Pentium® II Xeon™ Processor Specification Update

Release Date: October 1998

Order Number: 243776-006

The Pentium® II Xeon™ processor may contain design defects or errors known as errata which may cause the product to deviate from published specifications. Current characterized errata are documented in this Specification Update.

Figure 1. An Example of Micro-controller Driven Thermal Management

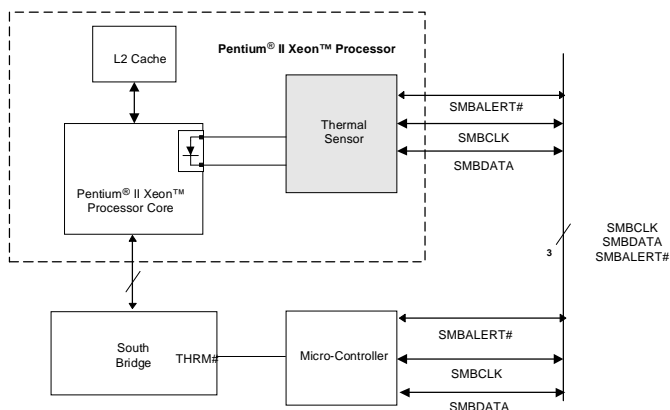
D30. Thermal Sensor May Assert SMBALERT# Incorrectly

PROBLEM: The Pentium II Xeon processor has a thermal sensor that monitors the processor core's temperature. The thermal sensor asserts SMBALERT# if the processor temperature exceeds the temperature limits set in the Alarm Threshold Registers (T_{HIGH}, T_{LOW}). It also sets the corresponding Status Register bits to identify the cause of the interrupt. Figure 1 gives one example of the how the SMBALERT# signal could be used in a system.

Under the conditions described below, the thermal sensor incorrectly generates the SMBALERT# interrupt. *All* of the following conditions must be met to trigger a false interrupt:

WORKAROUND: Three different (mutually exclusive) workarounds are possible:

1. Before servicing an interrupt from the thermal sensor, read and compare the processor thermal reading with the threshold limits (T_{HIGH} or T_{LOW}). Figures 2 and 3 provide basic flowcharts for the implementation of this workaround in an interrupt driven system.
2. If the firmware implemented polls the Status Register only, then before taking any action, re-read the temperature register and do a comparison with the alarm threshold limits (T_{HIGH} or T_{LOW}) to determine if the value is actually still within the temperature window.
3. Use a temperature polling scheme to monitor the processor temperature.
